**Re:** Consultation on an Application

**Planning Application Ref:** PL/26/0187

**Proposal:** Application for Approval of Details Reserved by Conditions 3 (materials), 5 (construction method statement), 20 (Habitat Enhancement) and 30 (SUDS) of permission PL/22/1405

To allow for tree planting and drainage, the trees are shown on the above as being within raised planters above the underground cellular storage, with services routes through the planter cells:

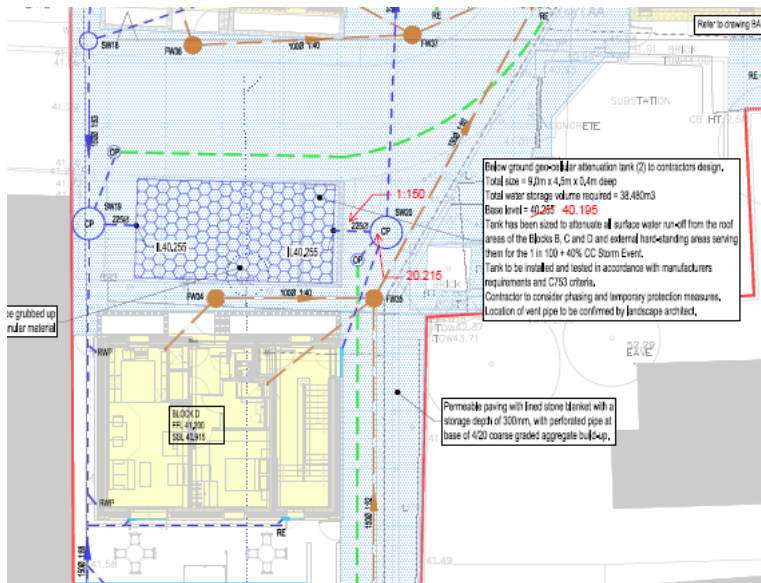
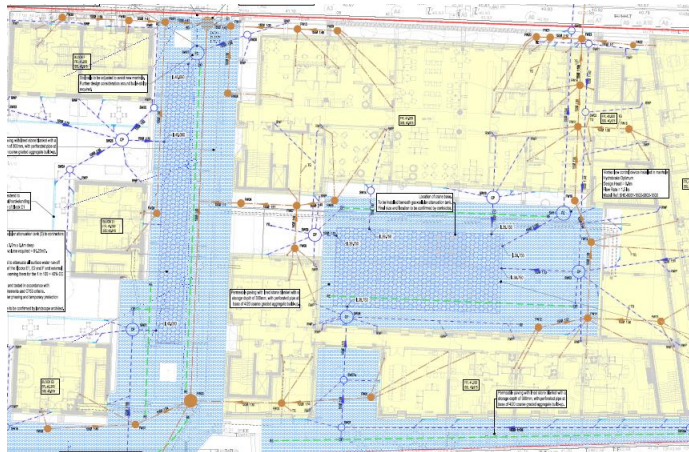
The attenuation tank in the main courtyard now longer covers the whole area (underground) hence no longer extends under all the tree planting. As such, clarity is required on the tree planting, specifically whether this is still retained within a raised planter over the whole courtyard or whether some trees will be 'in the ground', in which case new tree pit details will be required.

The attenuation under the Mews has reduce in length which may mean the tree pits details for the trees either end may need to be revised – clarity is required.

I note the comments of 20/4/26 from Darren Cook (SuDs officer) and that amendments have been requested to align the SuDs design with EN18 requirements, i.e. more landscape-led, which I support. Drainage into tree pits prior to the drainage system should be considered.
